## PROPOSED CODE CHANGES

## BUILDING CODE CHANGES

**TABLE 10**  
**COMPARISON OF MAXIMUM ALLOWABLE HEIGHTS AND AREAS OF SPRINKLERED ONE-STORY AND MULTIPLE STORY BUILDINGS**  
**EXISTING REQUIREMENTS VS. PROPOSED REQUIREMENTS**

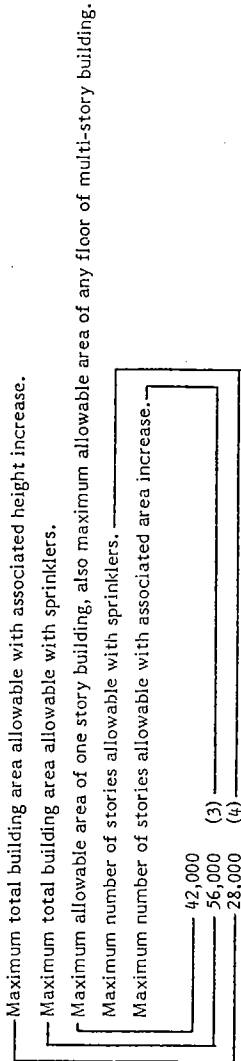
All the ramifications and interrelations of the height and area limit changes are not directly apparent from reading the actual proposed code change wording in Appendix A. In order to clarify the intent of these changes and to assist the reader in understanding the extent of the changes, Table 10 has been prepared. This table allows the comparison of existing maximum height and areas allowed for sprinklered buildings and the maximum height and areas that are possible as a result of the code changes. The maximum areas shown are based on the increases permitted only for automatic sprinklers and do not consider increases permitted for clear space separation around buildings. The cumulative corresponding maximum allowable area with sprinkler increases and clear space separation increases, however, can be determined by multiplying the area figures shown in the chart by a factor of two.
